CROSSROADS MIXED USE FILING NO. 1

COUNTY OF EL PASO, STATE OF COLORADO STORM SEWER PLANS

UNDERGROUND DETENTION
DECEMBER 2022

BaySeparator
Stormwater Treatment System

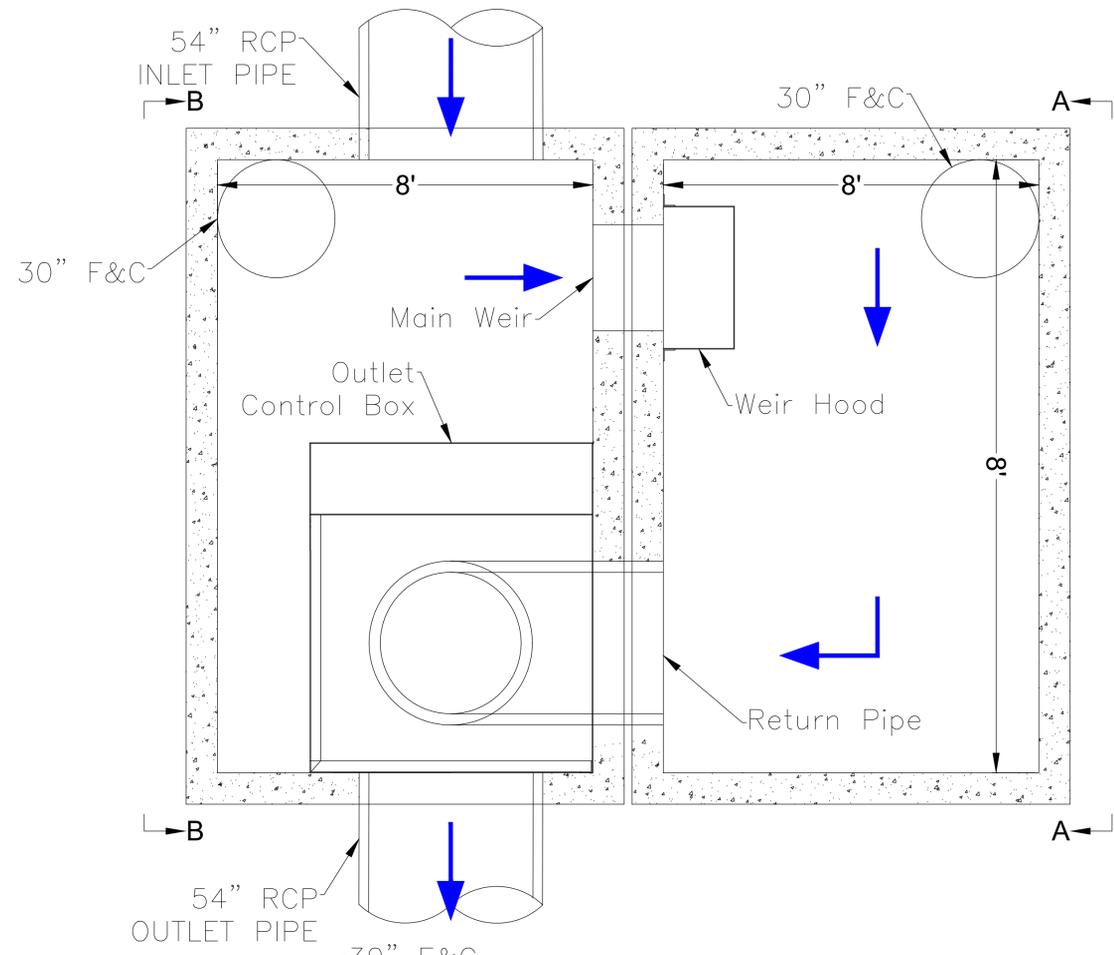
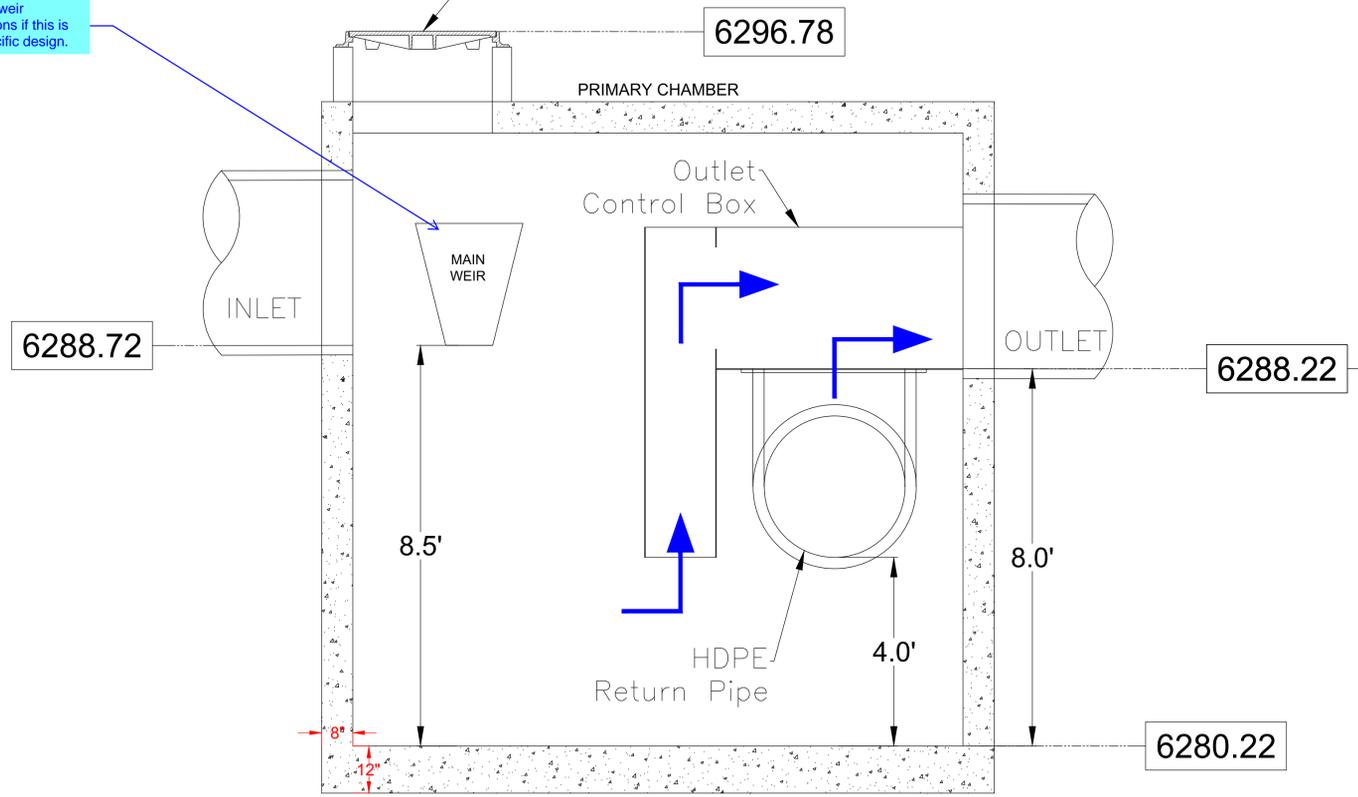
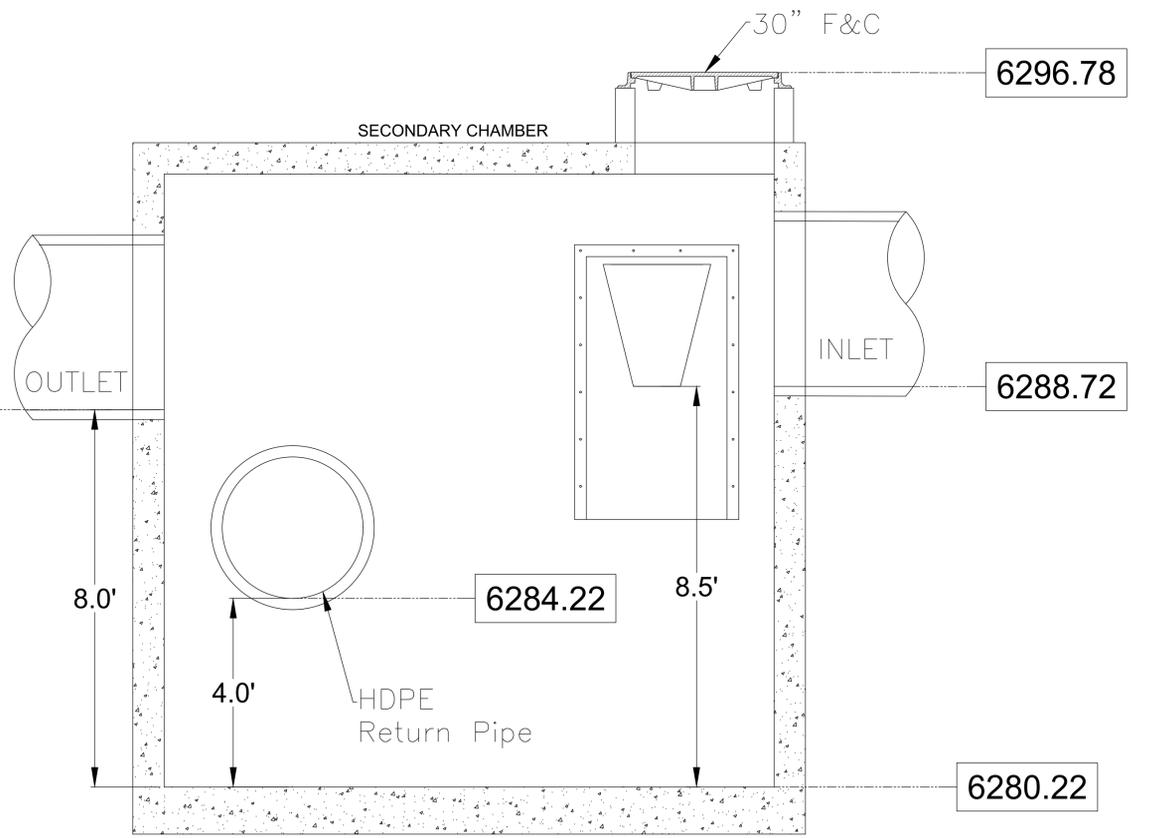
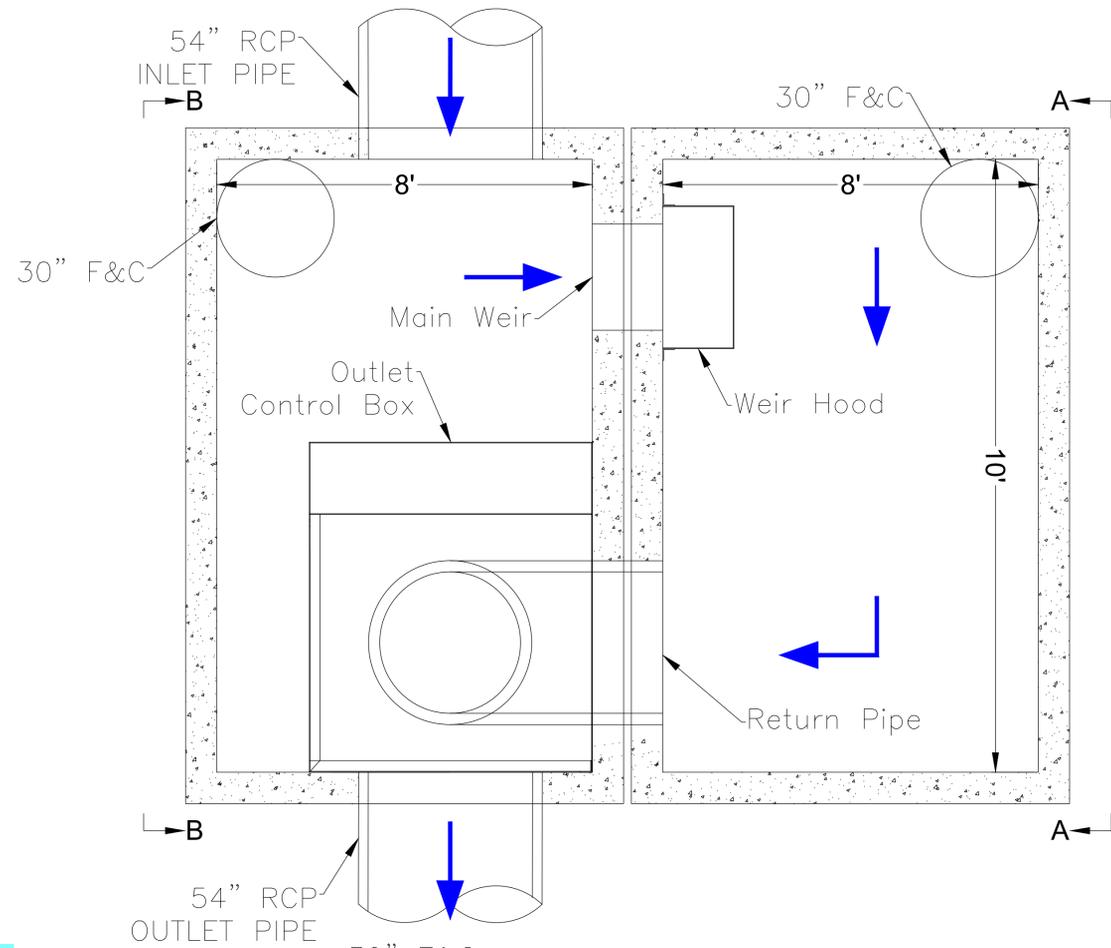
Provide and show the location and details for the steps to access the interior of the structure.

Clarify if this sheet is showing BS-1 or BS-2 to match labeling on detail sheets above.

Provide clarification in the drainage report.
The summary table notes 65.5 cfs peak flow rate which is less than the anticipated 100yr flowrates going into the bayseparator. This would backup the stormwater upstream of the Bayseparator. Should the peak flow rate be increased to match the inflow? Does the increase affect the TSS rate?

Provide weir dimensions if this is site specific design.

3 SHEET OF 3

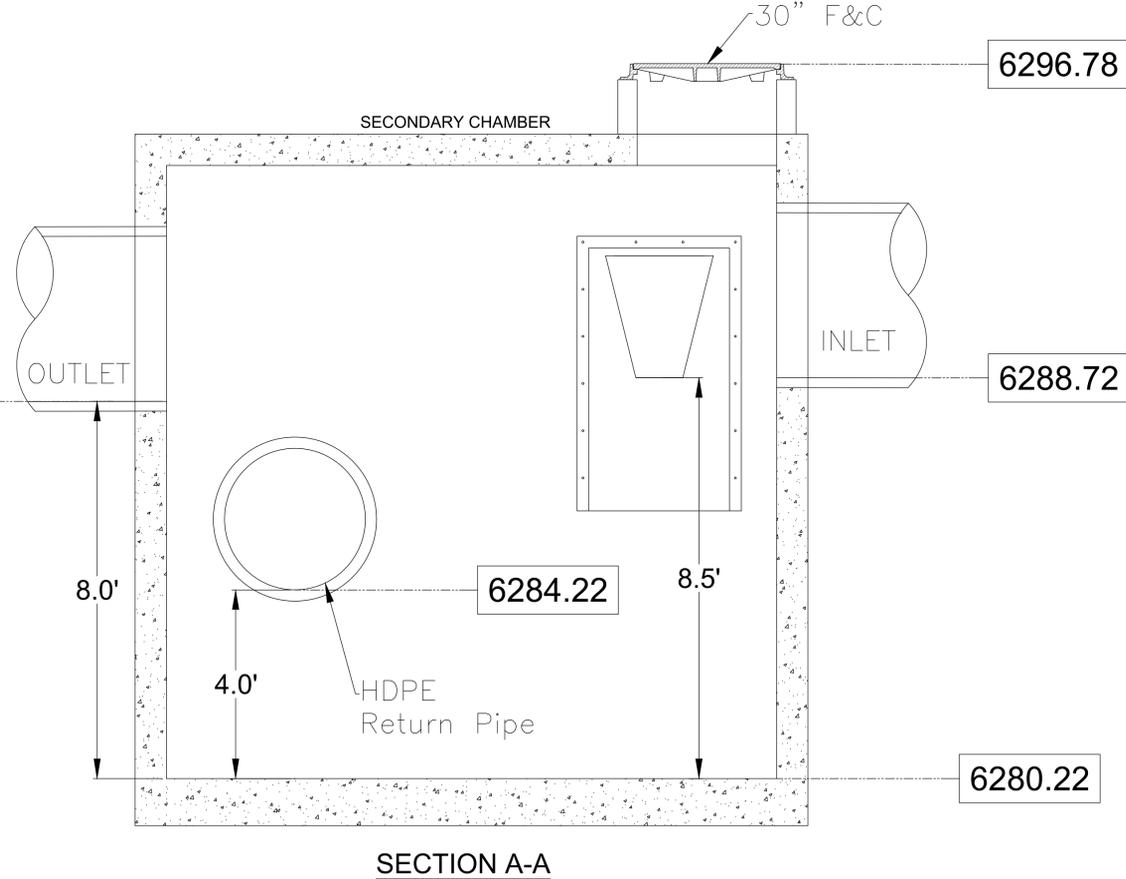
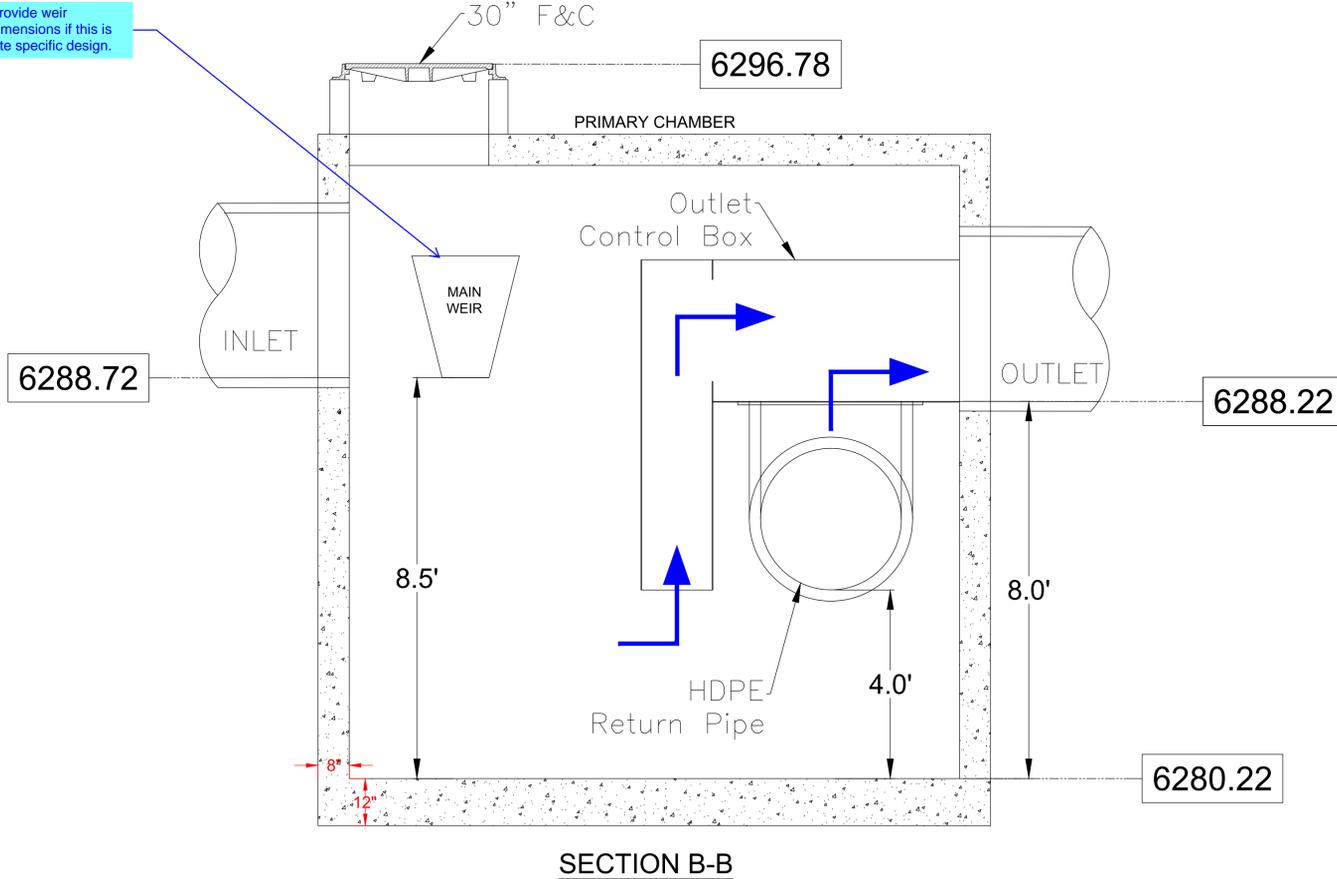
Provide and show the location and details for the steps to access the interior of the structure.

Clarify if this sheet is showing BS-1 or BS-2 to match labeling on detail sheets above.

Provide weir dimensions if this is site specific design.
